**TOWN OF BAY HARBOR ISLANDS
PLANNING AND ZONING BOARD**

December 11, 2018

FINAL AGENDA

**TOWN OF BAY HARBOR ISLANDS
COMMUNITY DEVELOPMENT
MEMORANDUM**

AS BUILT FIRST FLOOR PLAN

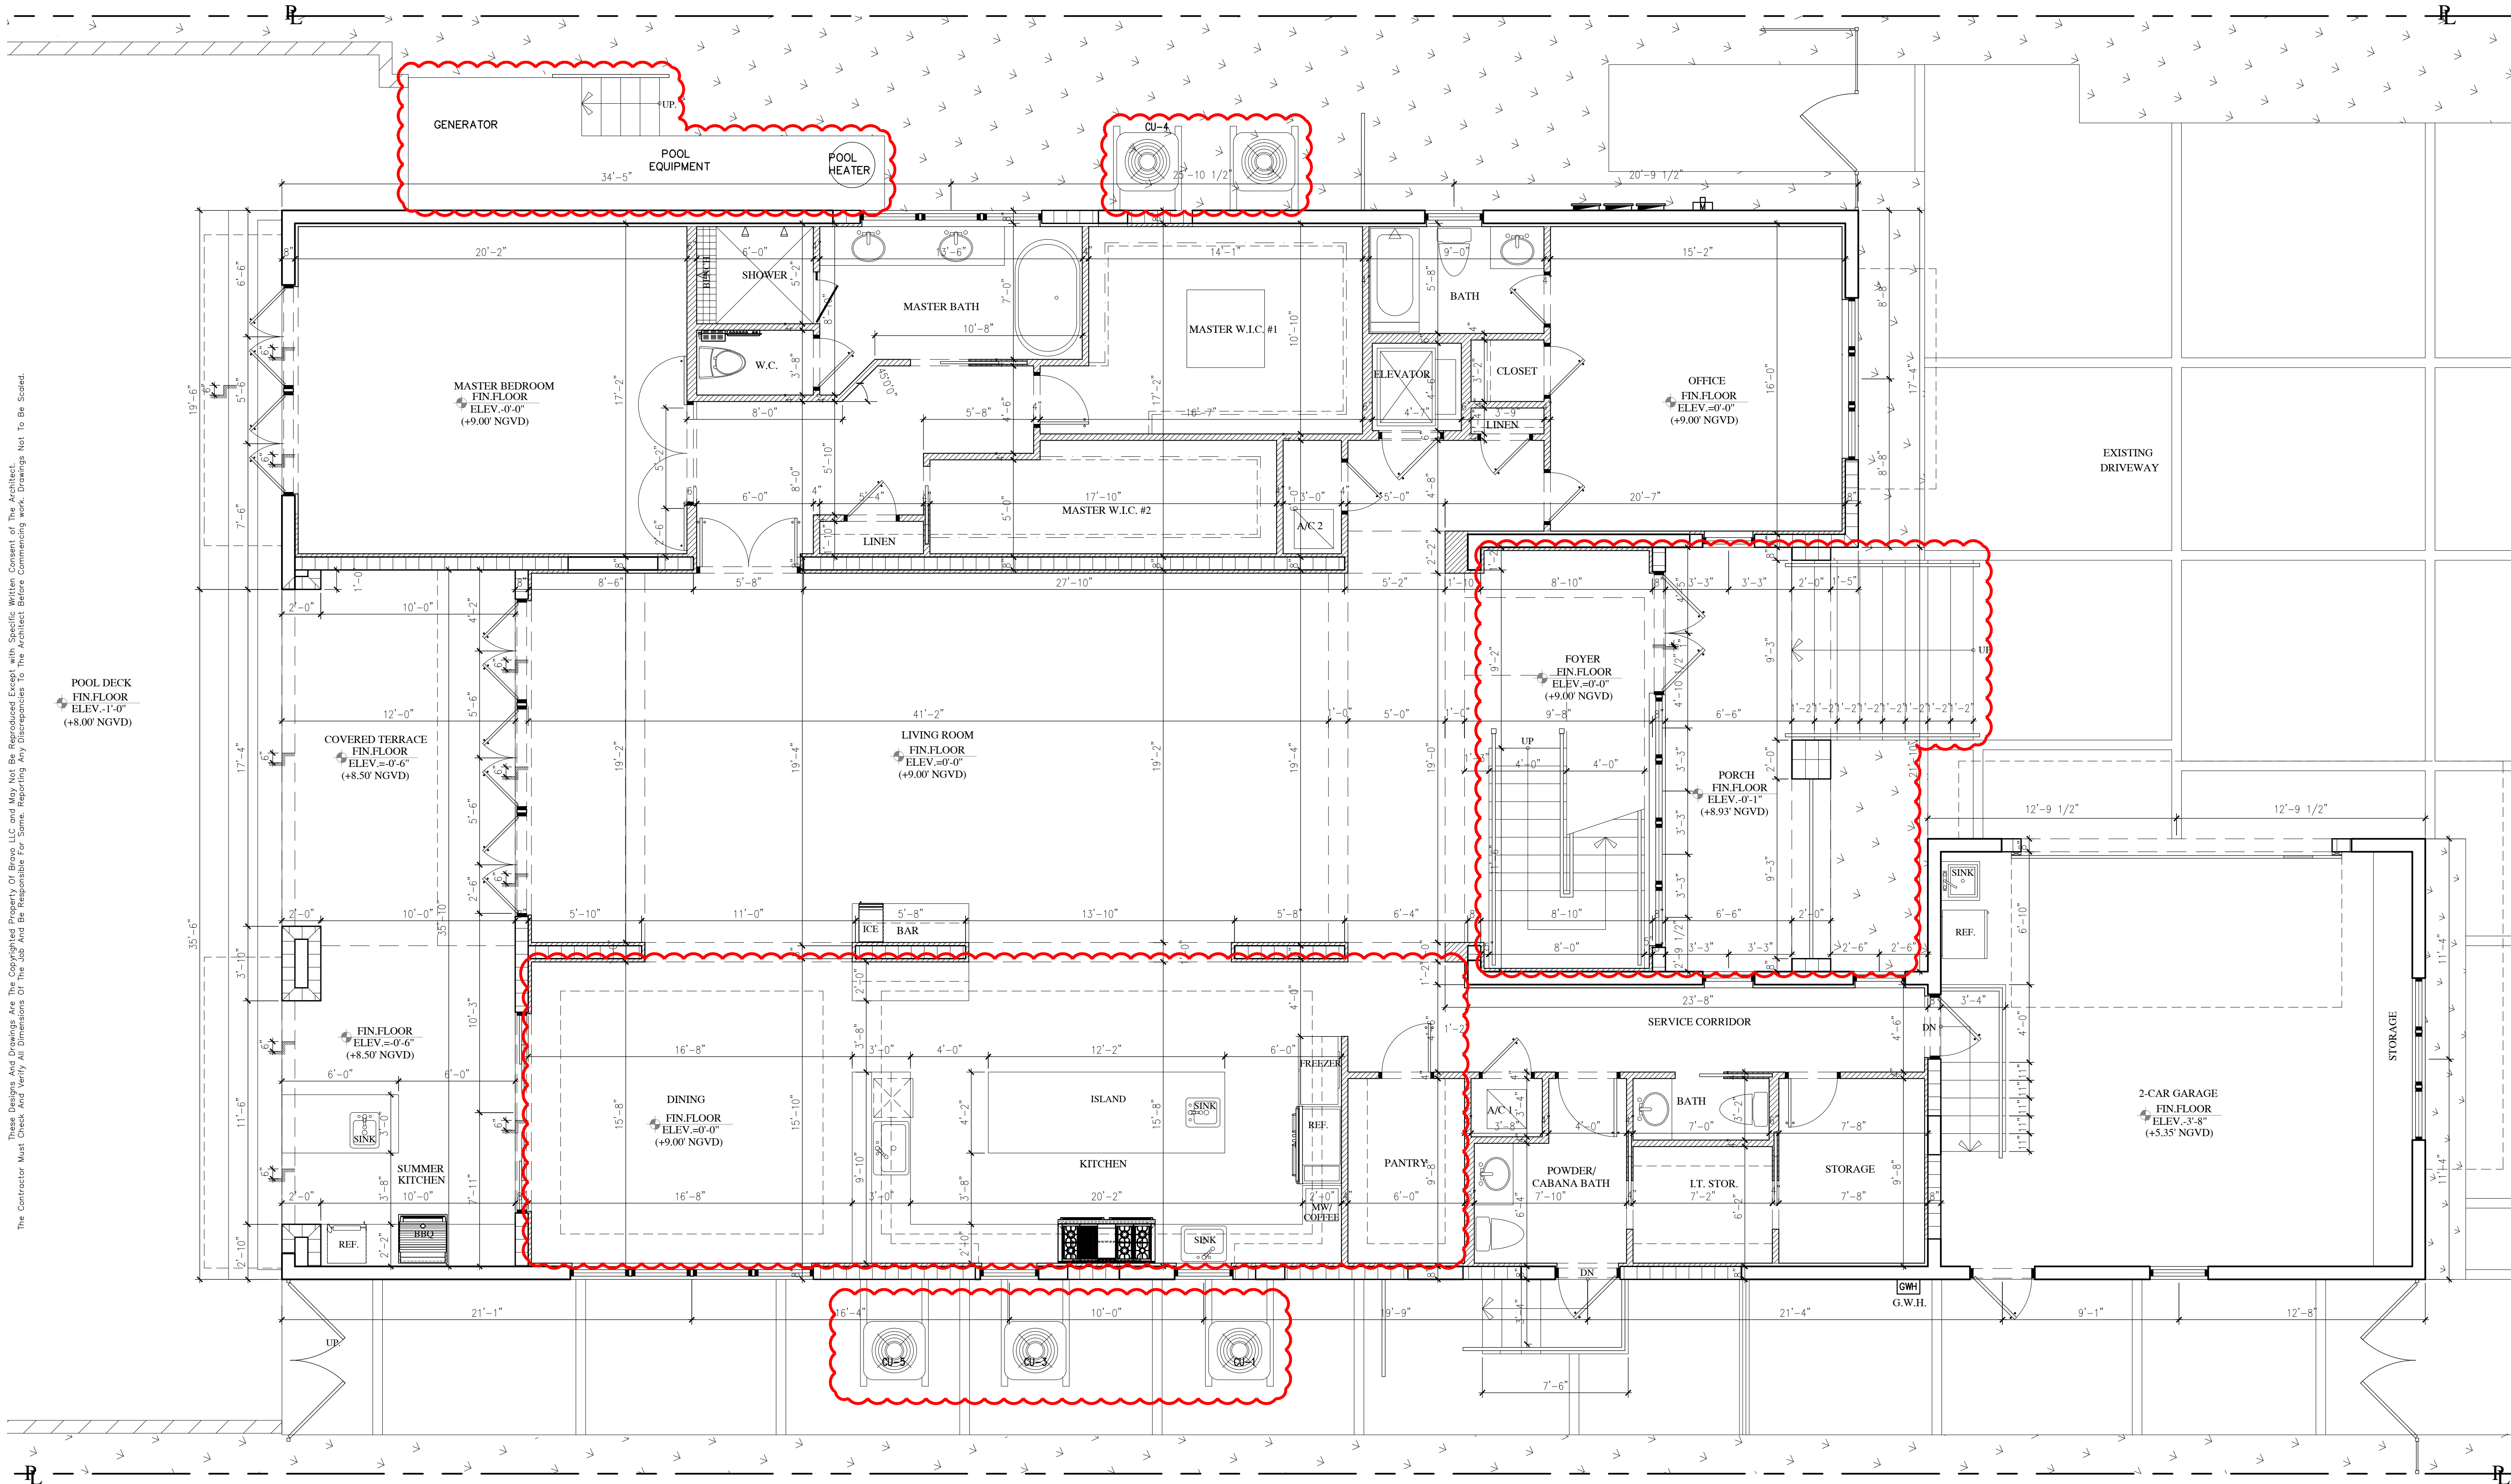
Sheet A-101 A:

A/C units shifted and steps to pool deck added on North setback area

Stairs and entry steps modified

Kitchen and Dining area modified

Walkway added on South setback area (variance granted)

AS BUILT SECOND FLOOR PLAN

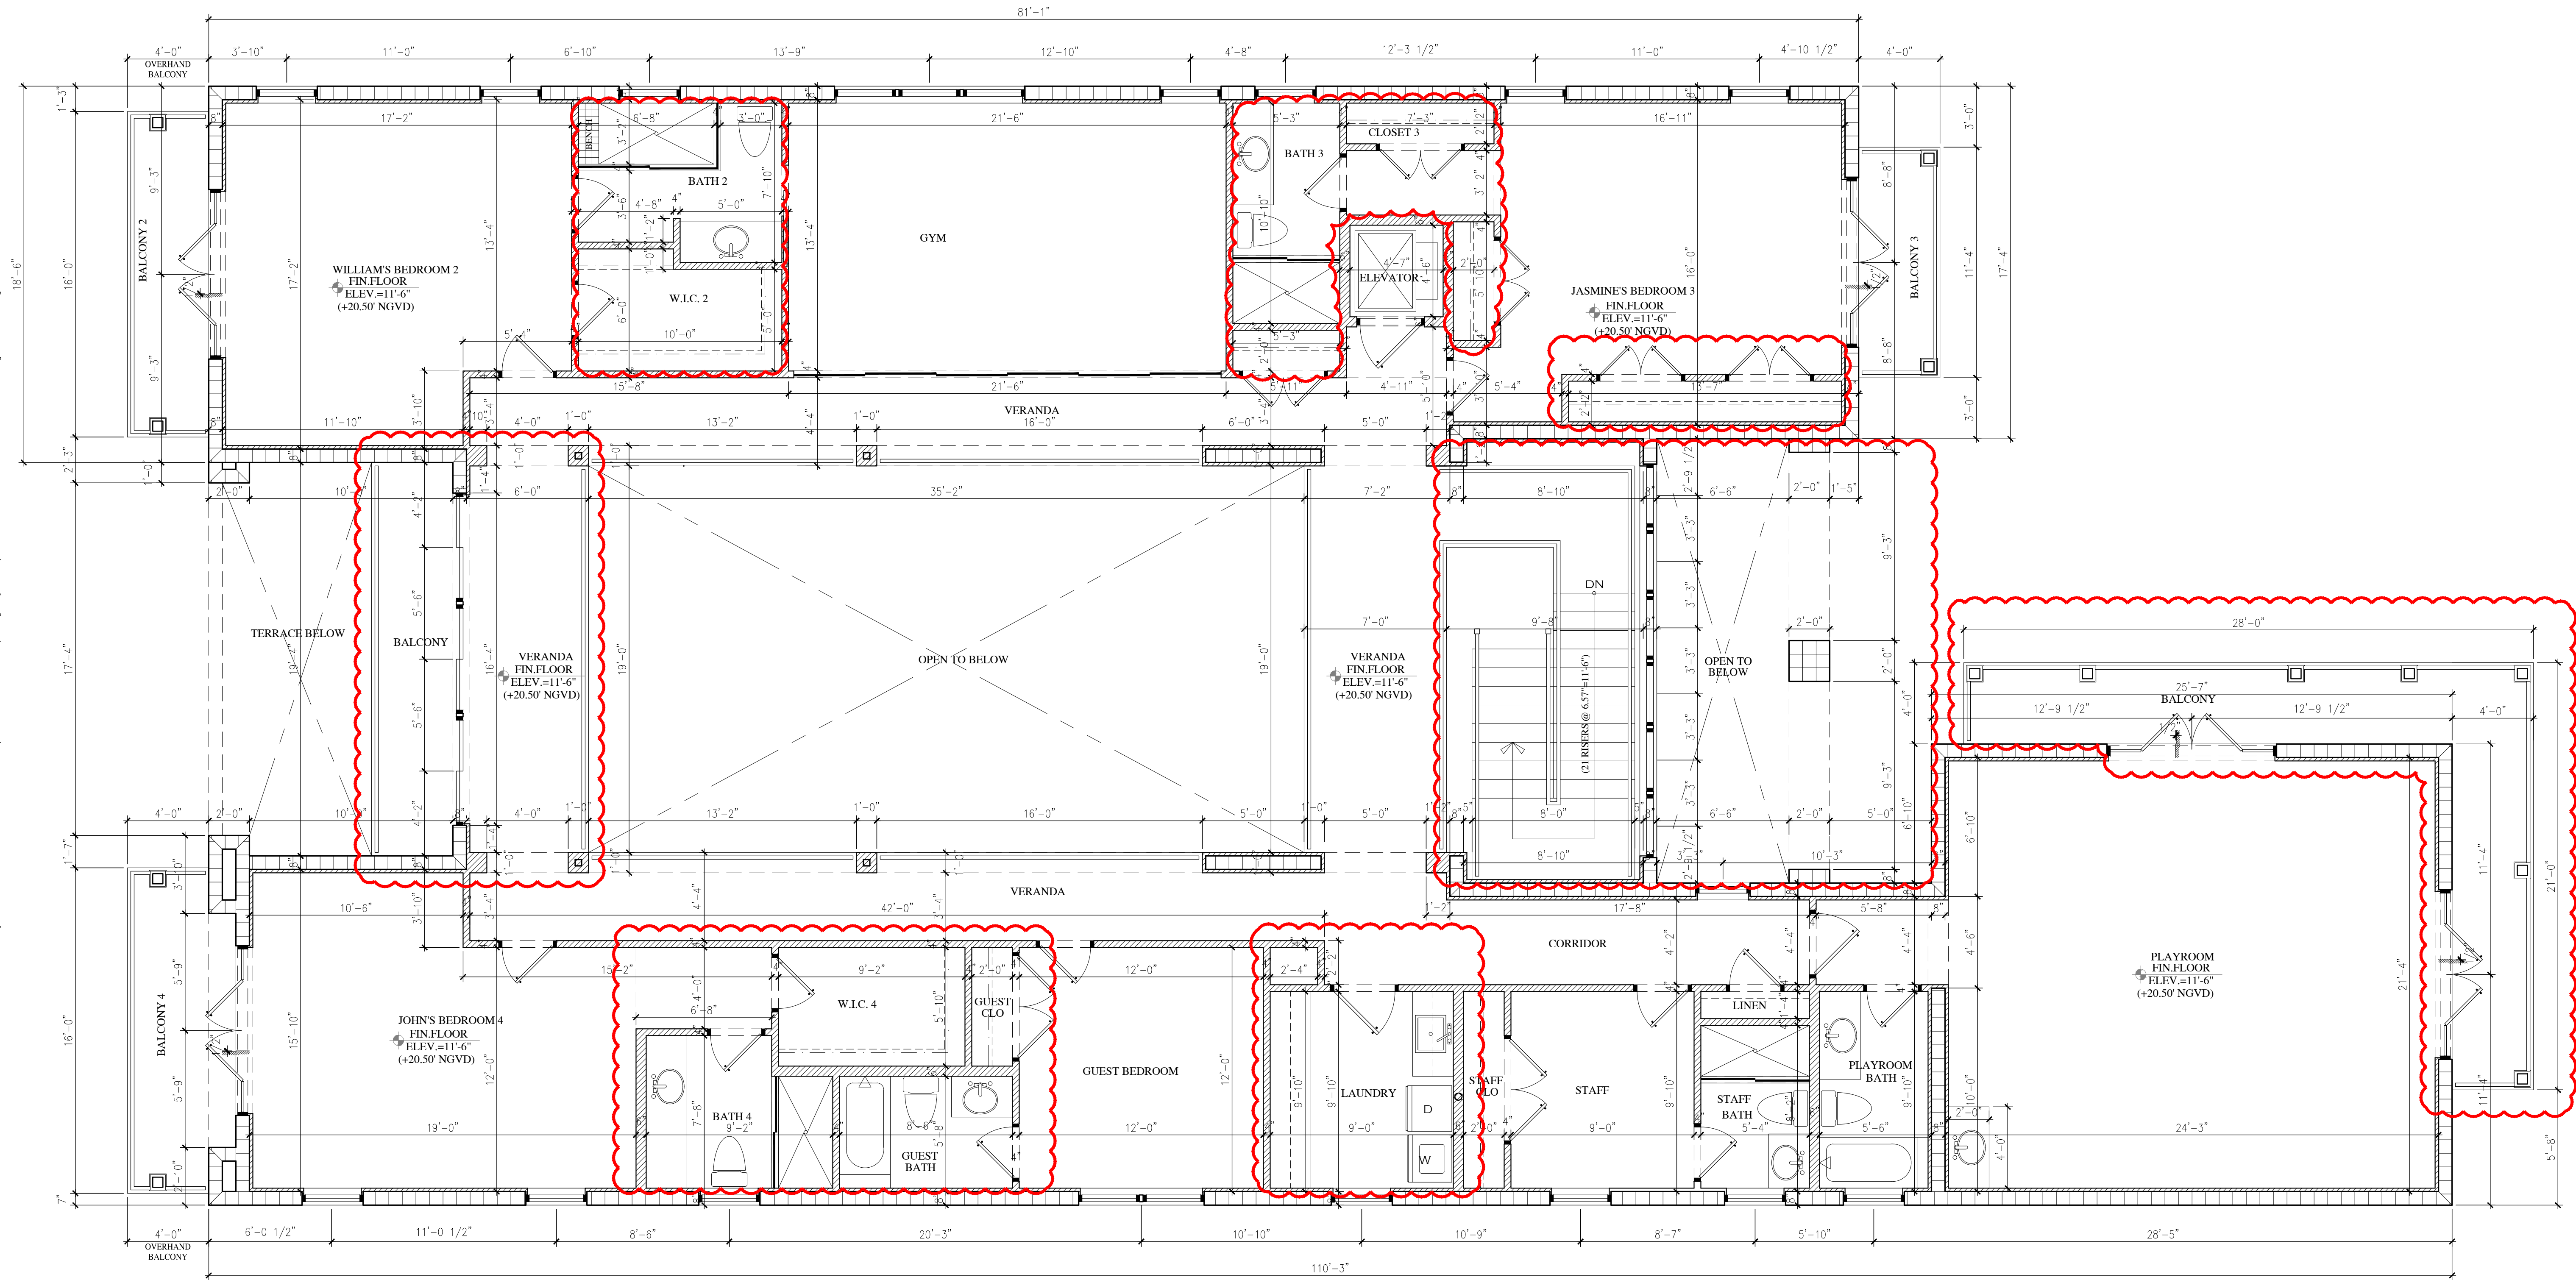
Sheet A-102 A:

Modifications to interior bathrooms and closet areas

Stairs modified

Balcony added on west side

LANDSCAPE PLAN
1/8" = 1'-0"
0' 8' 16' 24'

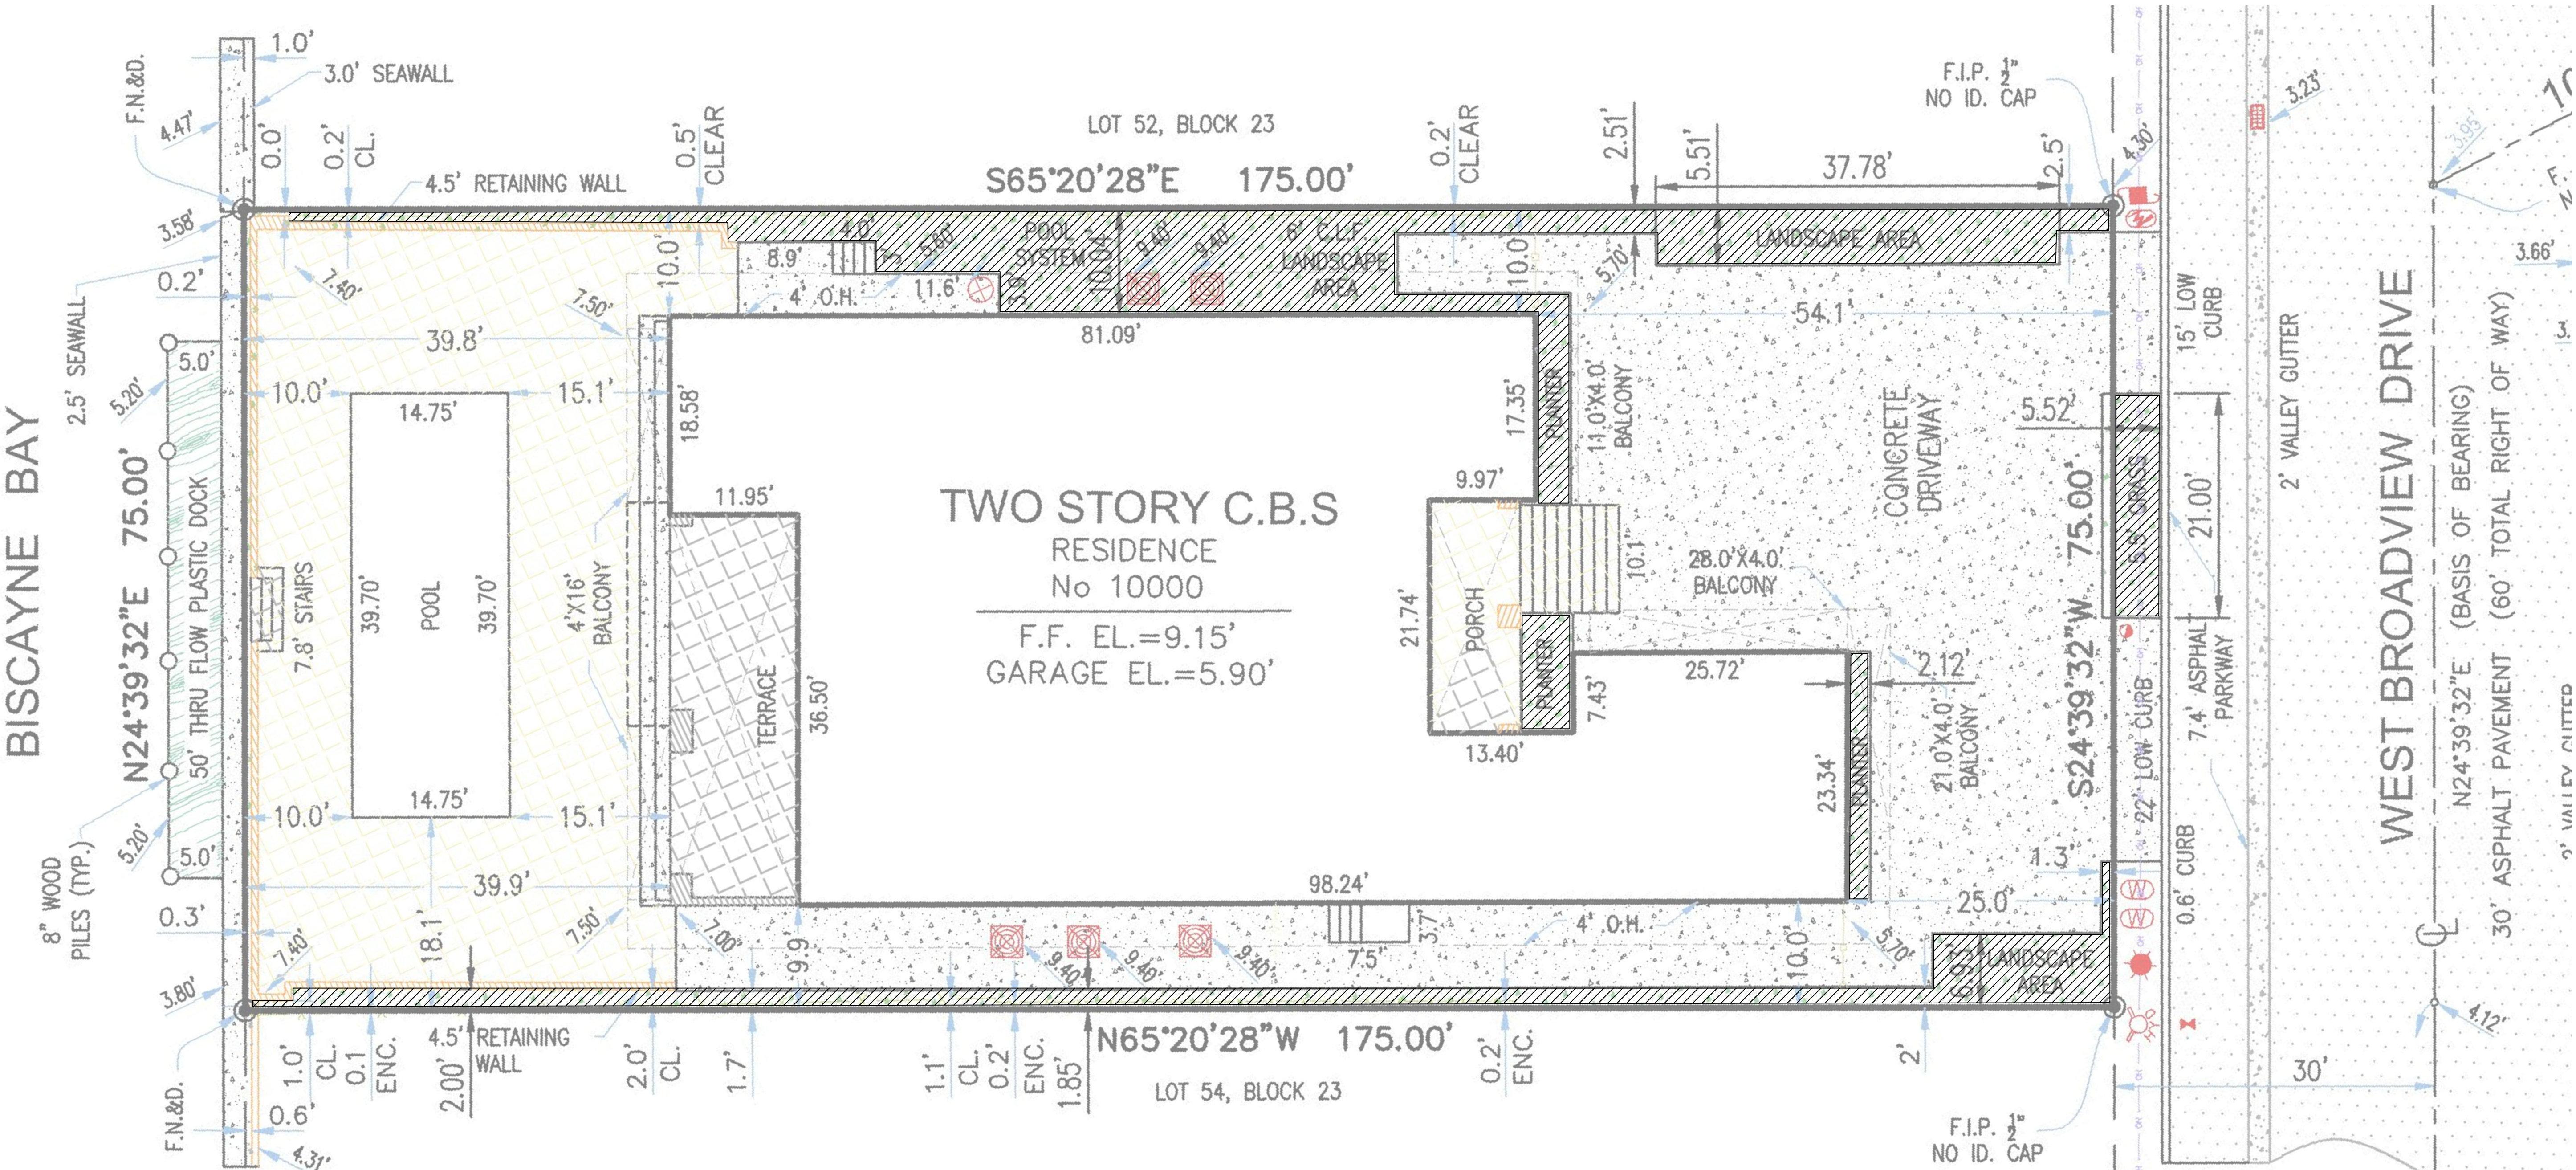
- 2) The following landscaping changes must be made in order for the plans to comply with the Miami-Dade / Town Landscape Codes:
 - a) Six (6) required shade trees meeting the size and height specification of the Town Code, specifically the Silver Buttonwood trees are to be at least 12 feet in height with at least 4' of clear wood before branching, with a minimum 2 ½" tree trunk caliper;

- b) Removal of the artificial turf from all side yards and replace with grass / gravel; and
 - c) As per the March 2016 approved plans, provide two (2) Glaucous Cassia in the front planter as the required Street Tree (no room in swale so Miami-Dade Landscape Code requires them in front yard near street) that are at least 15 feet in overall height with at least 6 feet of clear wood before branching, and a minimum 2 ½" tree trunk caliper.

- PLANNING ZONING COMMENTS
- THE SHADE TREE REQUIREMENT HAS BEEN UPDATED TO INCLUDE THE EXISTING BLACK OLIVE TREE. A TOTAL OF 6 SHADE TREES HAS BEEN PROVIDED.
 - ARTIFICIAL LAWN HAS BEEN REMOVED AND REPLACED WITH GRAVEL AGGREGATE.
 - THE SPECIFICATION FOR THE SILVER BUTTONWOOD TREES HAS BEEN REVISED TO BE 12' HEIGHT.
